REVISED STAFF REPORT: JUNE 11, 2025 MEETING

APPLICATION NUMBER: HDC2025-00264

ADDRESS: 1036 HUBBARD

SCOPE: ERECT CARRIAGE HOUSE, REAR PORCH (WORK COMPLETED WITHOUT APPROVAL)

Site plan and elevations. Applicant documents.

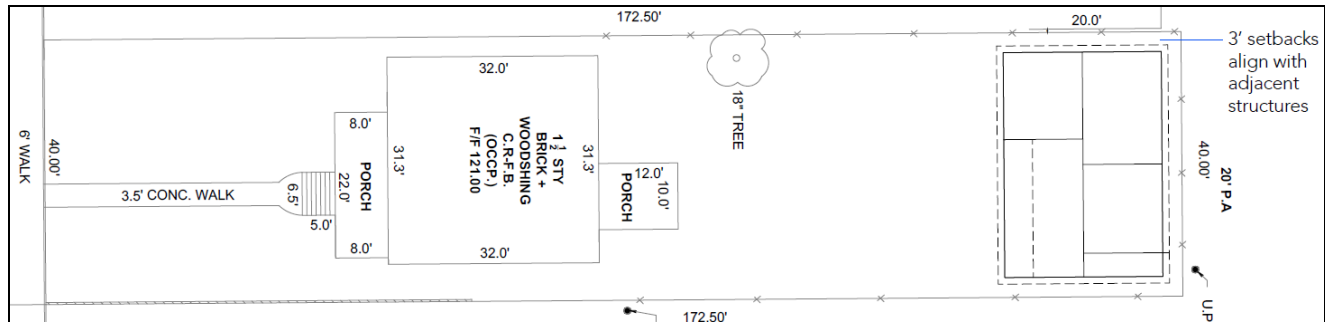
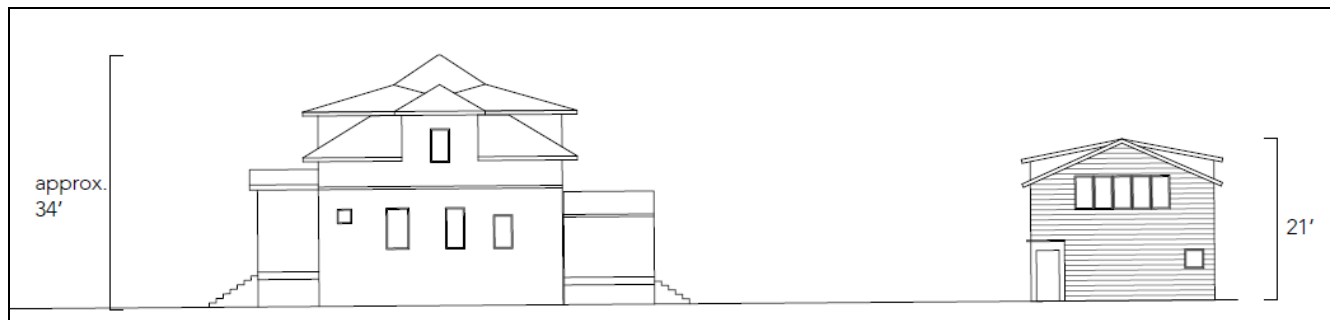
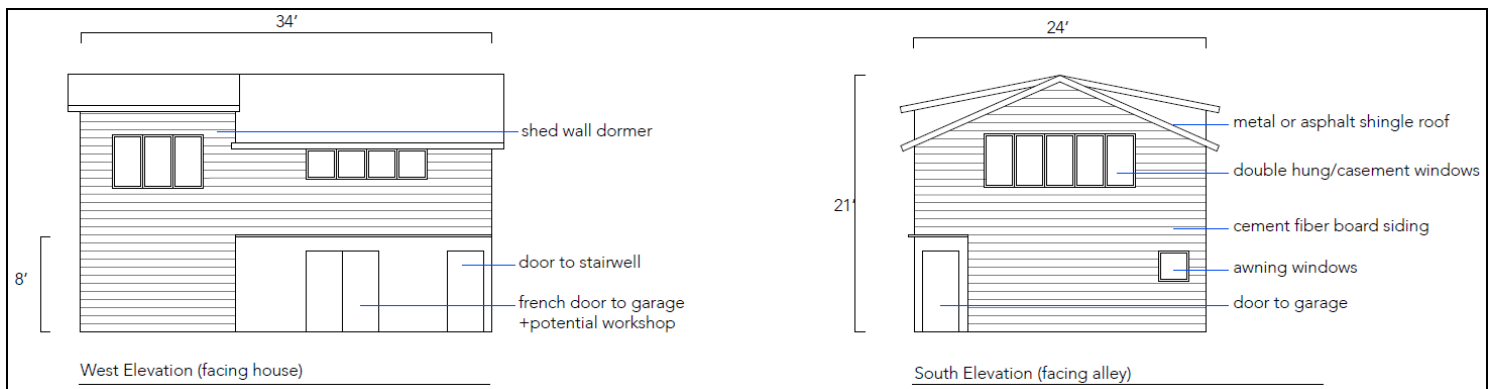
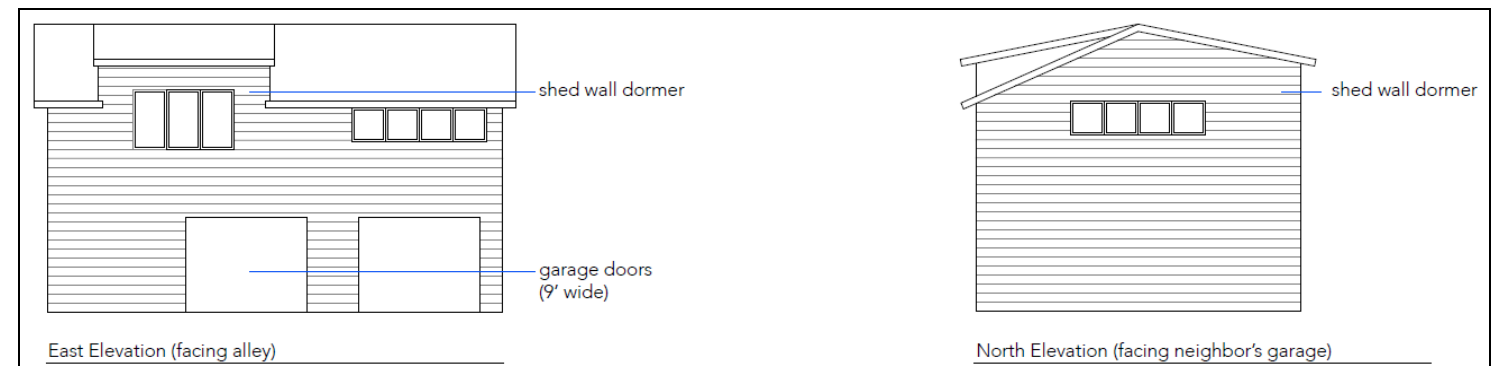
Staff comment: Staff recommends revisions to the design. The applicant states that the carriage house will "incorporate the wall dormer that is a notable feature of the existing main house." Staff appreciates the applicant's effort to mimic the partially extending second story walls of the historic house; however, the resulting varying roof pitches and eave heights, and a partially recessed first floor wall (creating a garrison-like effect to this structure), none of which are features on the historic house or surrounding historic garages, creates disproportionate wall and roof patterns for each side of the new structure. The carriage house must be subordinate to the lot's historic house. Copying or modifying distinctive character-defining features of the historic house, thus creating new, distinctive features for the carriage house creates an incompatible design within this historic environment.

Design considerations include the use of a symmetrical gable or hip roof; traditional hip or shed roof dormers inset from the roof edge, similar to adjacent historic garages; one-over-one double-hung and square awning windows, and exterior walls that extend to grade. These suggested design considerations are further supported by the following elements of design.

Staff comment: The applicant suggested double-hung or casement windows for the taller than wide windows. The dominant window operation on the house is double-hung, so double-hung (and not casement) is the compatible option for the taller-than-wide windows on carriage house. The house has at least one square window on three of the four sides of the house, so using square windows on the carriage house, whether single or grouped openings, is compatible for the new construction.

Staff comment: The dominant wall cladding proposed for the carriage house is cementitious lap siding. Lap siding is a compatible treatment for this new structure, as lap siding was commonly used in the early 20th century for garages, even when the house had brick veneer (additionally, this house has wood shake siding at the second floor). However, additional details - including dimension of lap exposure, surface finish (smooth), and window casings and wall trim – must be detailed on dimensioned elevation drawings. Staff will inquire about the secondary wall material at the recessed wall and sides of the extended second floor side walls depicted on the current drawings.

Regarding the proposed structure, the inset wall and varying eave heights and roof pitches create a uniquely busy design form for the carriage house and is atypical of the historic house and surrounding historic garages.

Staff comment: The asymmetrical roof includes one section with a more steeply pitched plane and is not compatible with the surrounding uniformly pitched historic gable and hip roofed garages.

- The varying roof pitches and eave heights, and a partially recessed first floor wall (creating a garrison-like effect to the structure), create an incompatible shape and massing that is in contrast with the early 20th century house surrounding site and conflicts with Standard 9 which states “new work shall be differentiated from the old and shall be compatible with the massing, size, scale, and architectural features to protect the historic integrity of the property and its environment”.

- In an attempt to replicate, in a modified form, a distinctive character-defining feature of the historic house, new, distinctive features were created for the carriage house that are atypical of the historic house and the adjacent historic garages. Therefore, the proposed design and massing are not subordinate to the historic house and the lot’s historic environment.

- The asymmetrical roof includes one section with a more steeply pitched plane and is not compatible with the consistent roof pitches on the historic house nor the surrounding historic gable and hip roofed garages.

Recommendation 1 of 2, Denial – Carriage House

- The varying roof pitches and eave heights, and a partially recessed first floor wall (creating a garrison-like effect to this structure), create an incompatible shape and massing that is in contrast with the early 20th century house and conflicts with Standard 9 which states “*new work shall be differentiated from the old and shall be compatible with the massing, size, scale, and architectural features to protect the historic integrity of the property and its environment*”.

- In an attempt to replicate, in a modified form, a distinctive character-defining feature of the historic house, new, distinctive features were created for the carriage house that are atypical of the historic house and the adjacent historic garages. Therefore, the proposed design and massing are not subordinate to the historic house and the lot's historic environment.

- The asymmetrical roof includes one section with a more steeply pitched plane and is not compatible with the consistent roof pitches on the historic house nor the surrounding historic gable and hip roofed garages.

Rear Porch

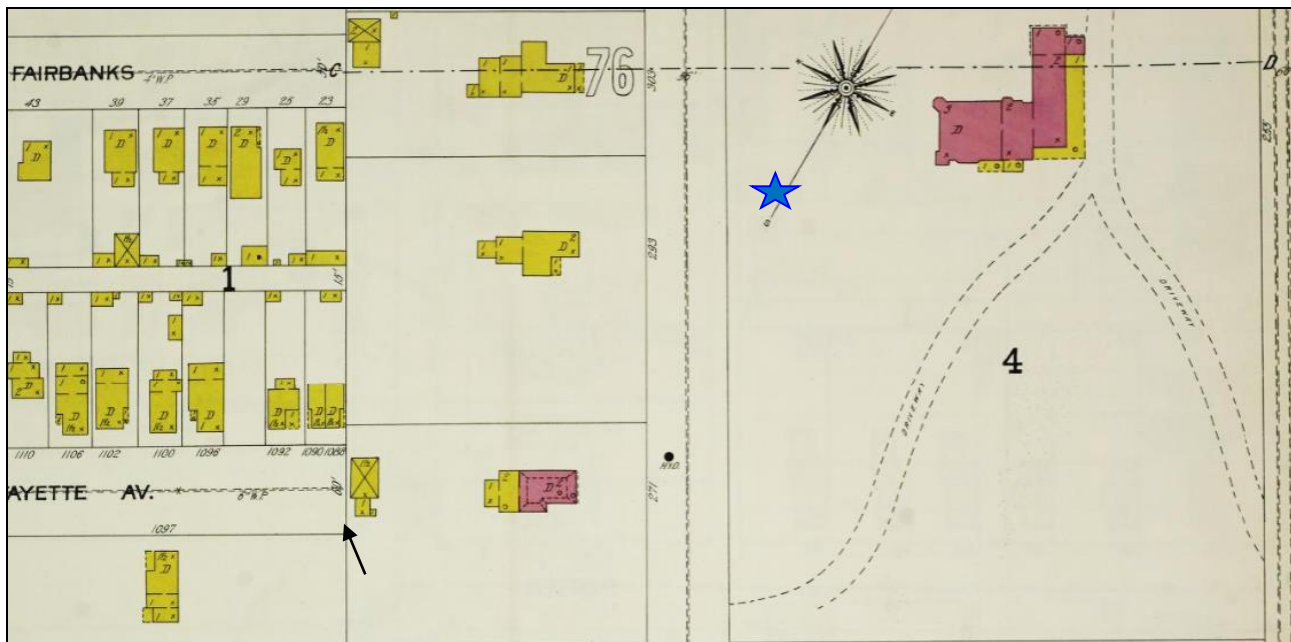
- Staff notified the applicant that the previously erected rear porch requires HDC approval; the applicant/owner agreed to add it to this application. On June 6, staff received a one-page document explaining the design details and its 2020 erection, as well as photos of the completed work. It is staff's opinion the screen porch is compatible with the house in massing, location and design. However, the remaining unfinished wood elements (balustrade, stairs and wood wing wall) should be painted to match the painted wood porch framing and railing baluster.

Recommendation 2 of 2, Certificate of Appropriateness: Erection of rear porch

- The unpainted elements will be painted to match the existing painted porch framing and railing baluster.
